FINAL PLAT
HAWTHORNE ADDITION
AN ADDITION TO WICHITA, SEDGWICK COUNTY, KANSAS

RE: SUB 2002-56 -- Final Plat of Hawthorne Addition

CASE NUMBER: SUB 2002-56 -- HAWTHORNE ADDITION

FINAL PLAT

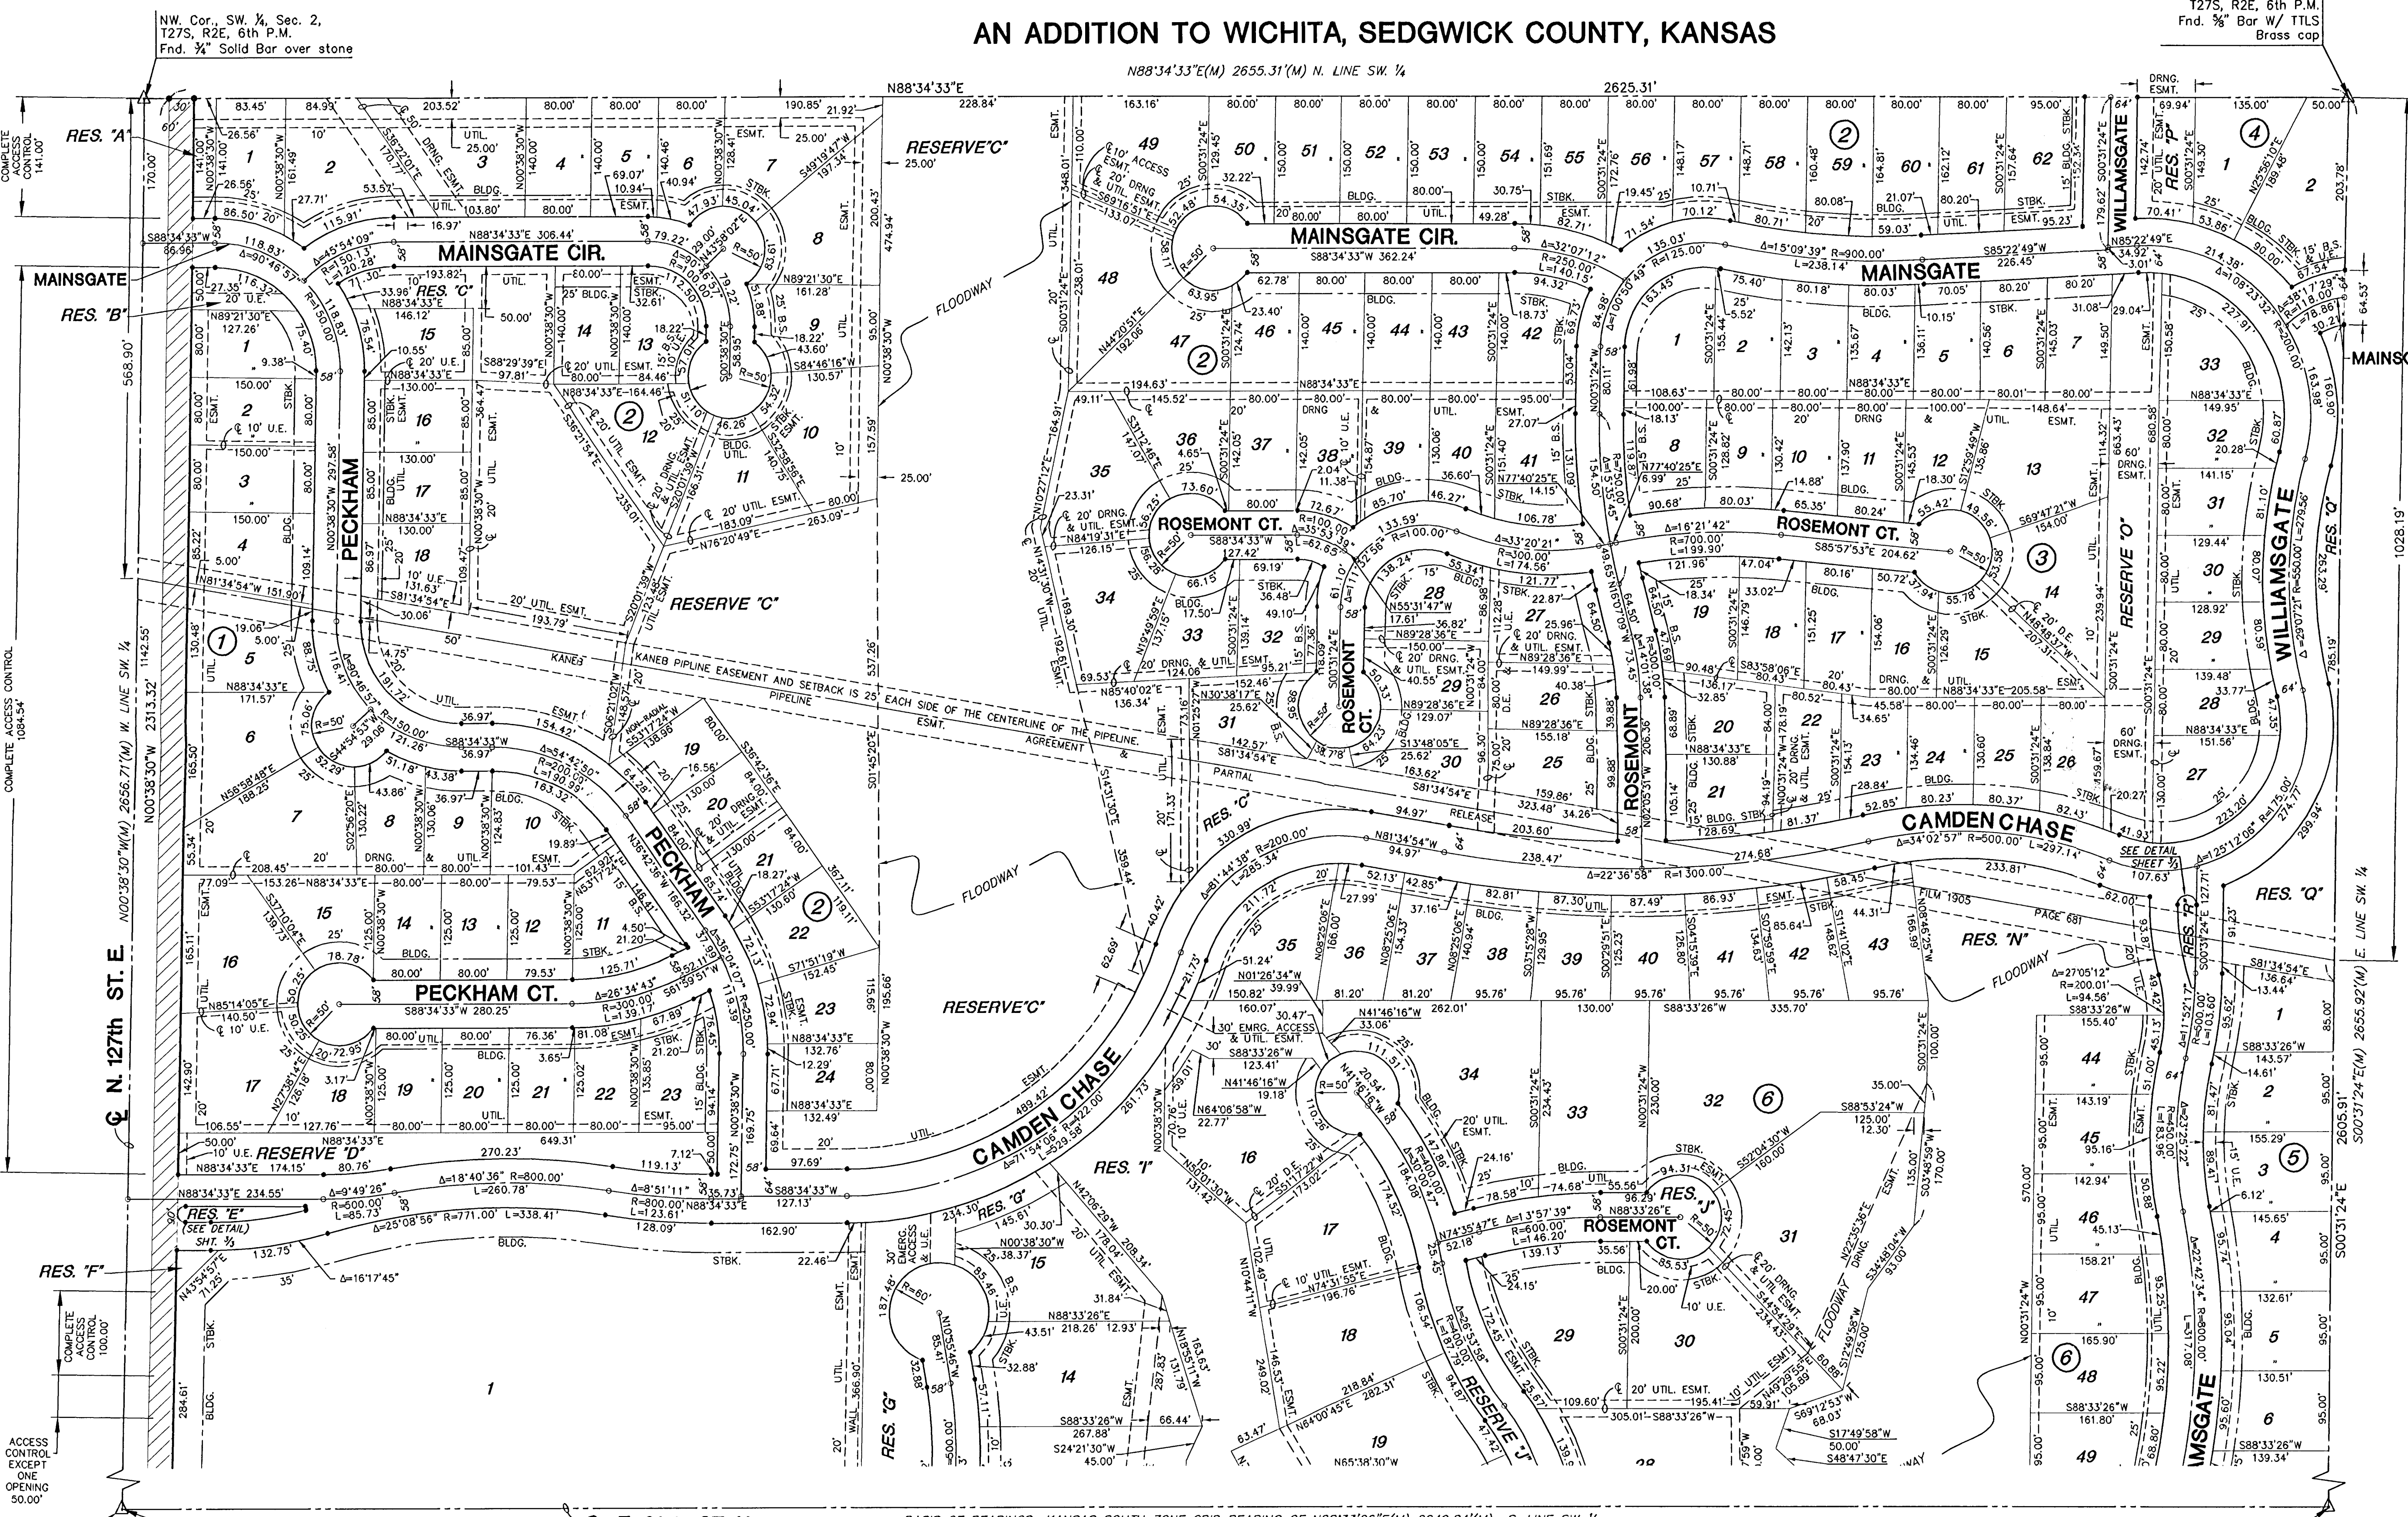
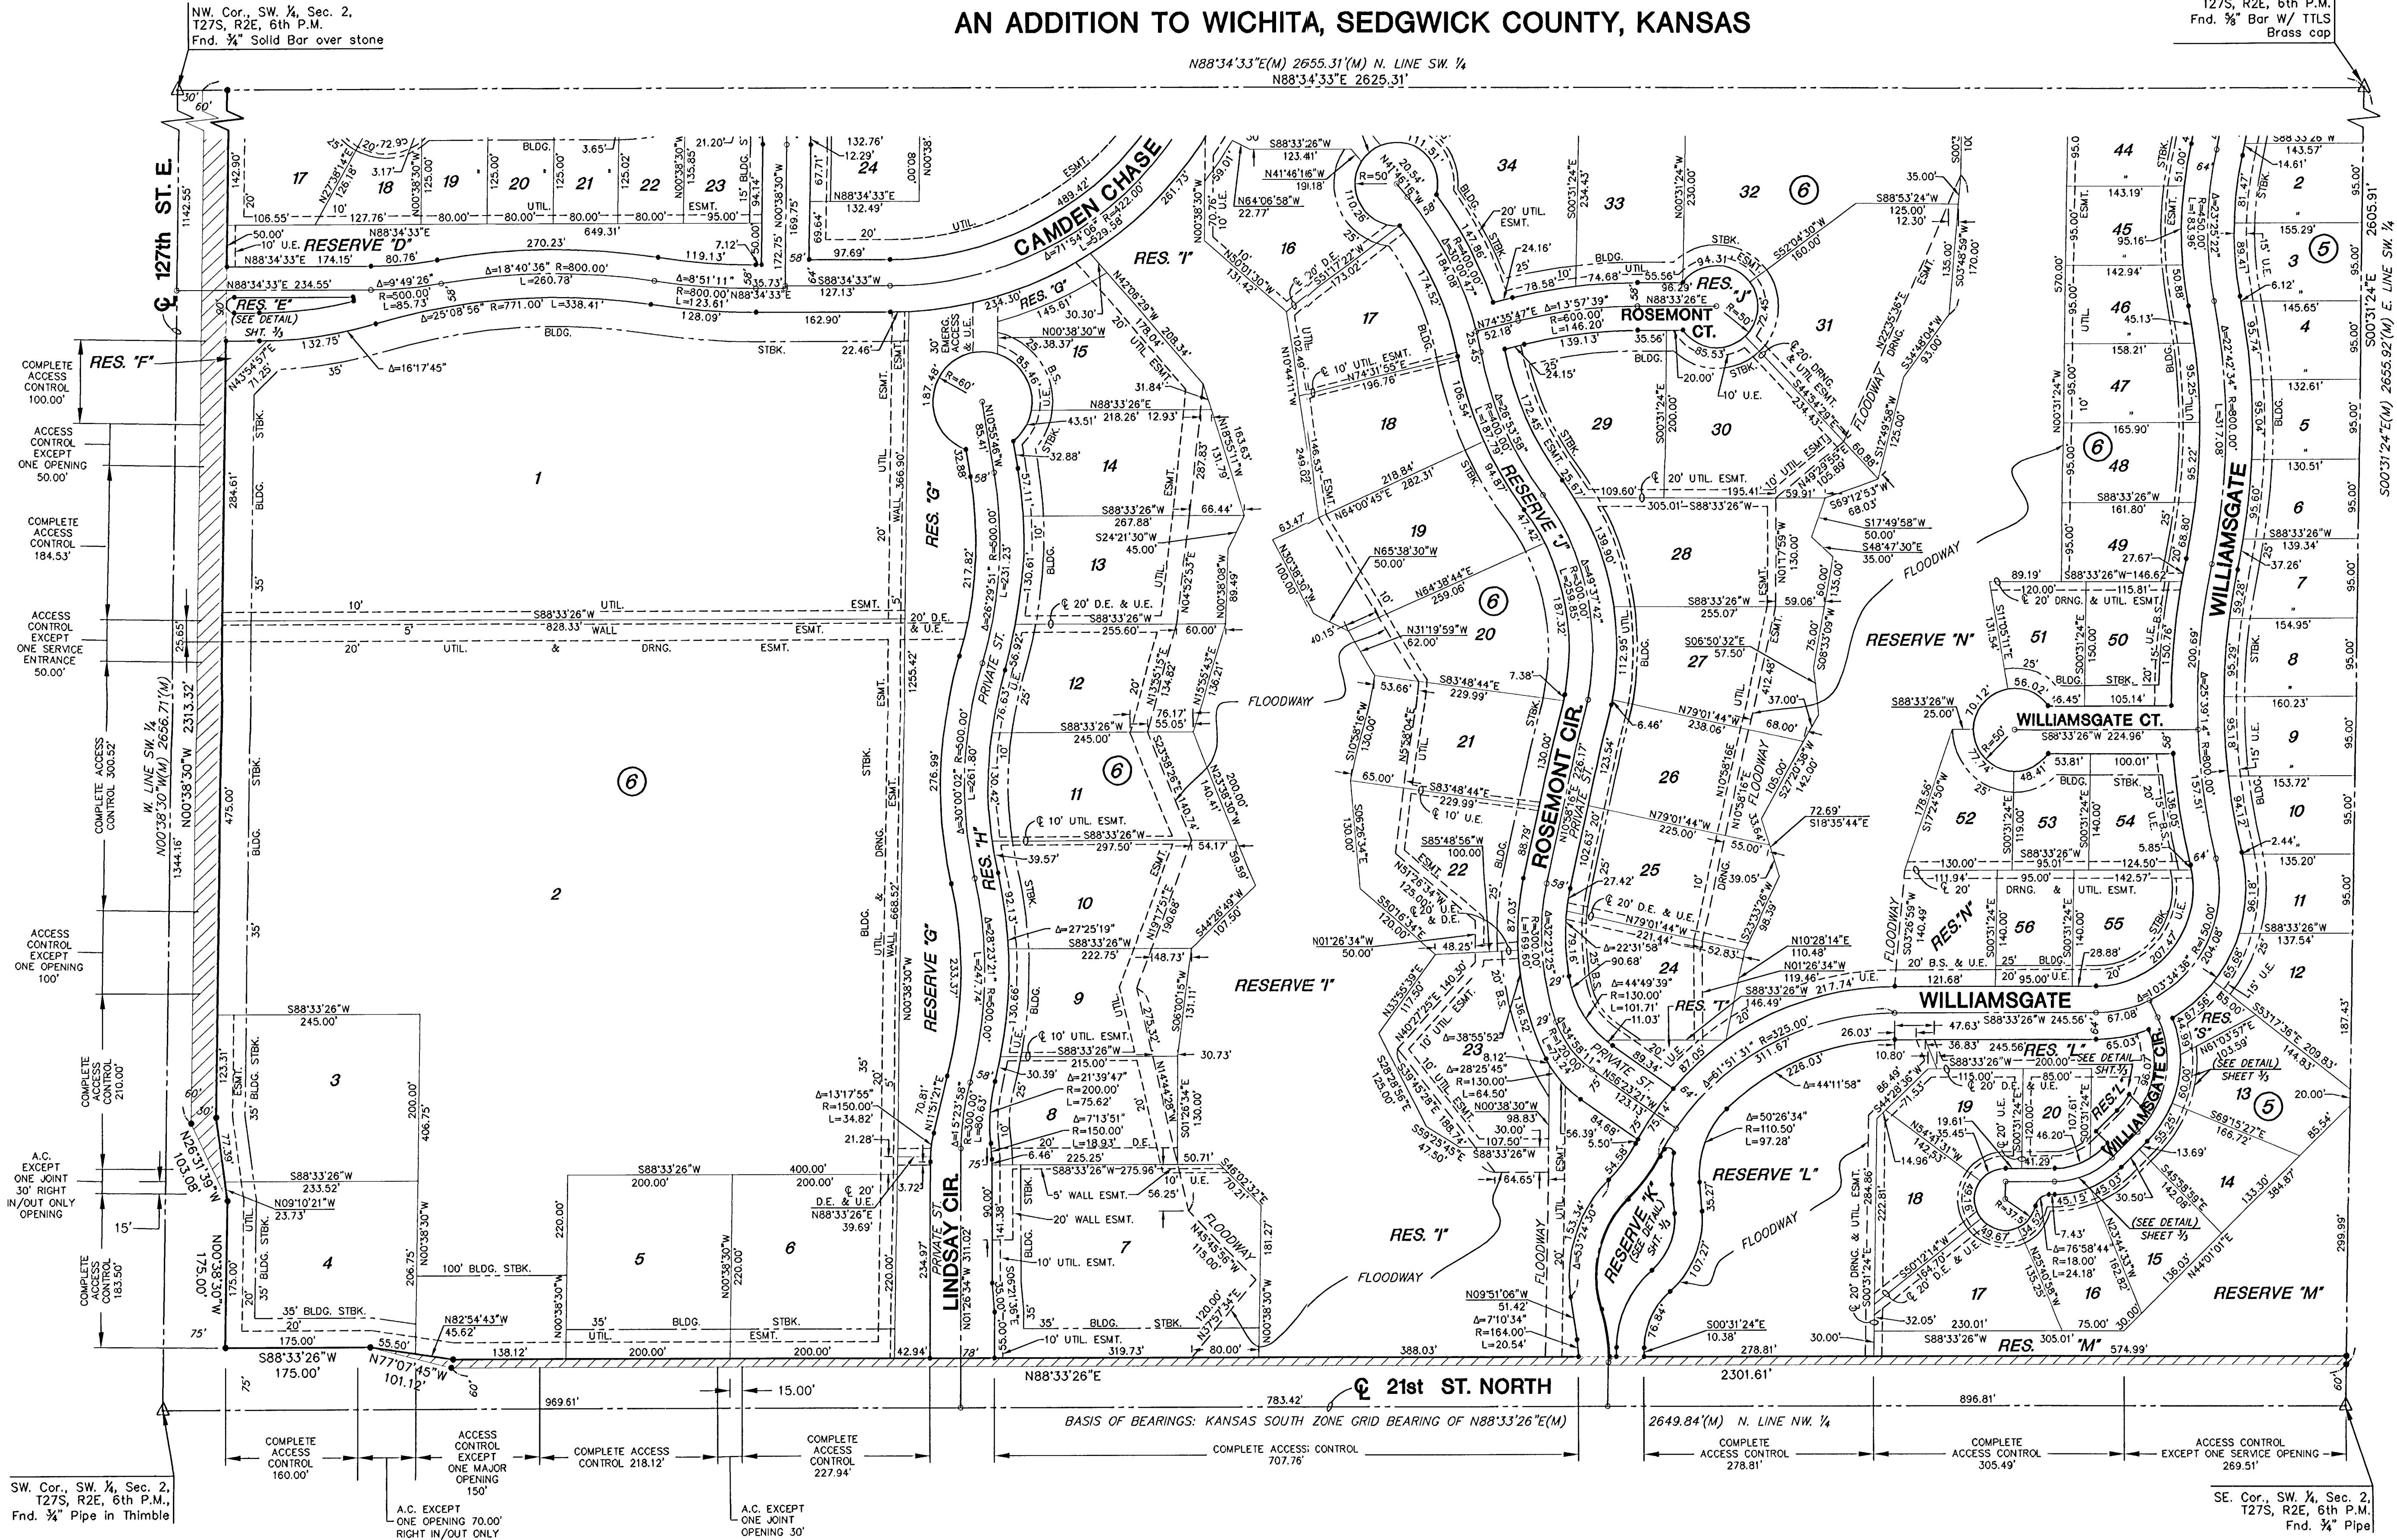
- D. The drainage plan is approved. A guarantee is required.
- E. The approved CUP permitted 4 openings along 127th St. East and three openings along 21st St. The CUP also required joint access openings between Lots 3 and 4, and between Lots 5 and 6. Right turns only were required for the openings closest to the intersection. The access controls on the plat conform with the CUP. The dedication of access controls in the plat's text shall reference Block 6.

An opening has been platted along 21st Street. This opening needs to be labeled as a "service opening".
- O. Provisions shall be made for ownership and maintenance of the proposed reserves. The applicant shall either form a lot owners' association prior to recording the plat or shall submit a covenant stating when the association will be formed, when the reserves will be deeded to the association and who is to own and maintain the reserves prior to the association taking over those responsibilities.

- S. The City Fire Department/GIS needs to comment on the plat's street names. Hawthorne shall be revised to Williamsgate. Rothbury shall be revised to Mainsgate. Rosemont Circle which extends into Block 2 shall be revised to Rosemont Ct.

- V. The recording information for all pipeline easements shall be indicated on the face of the plat.
- W. Based upon the platting binder, property taxes are still outstanding. Before the plat is scheduled for City Council consideration, proof shall be provided indicating that all applicable property taxes have been paid.
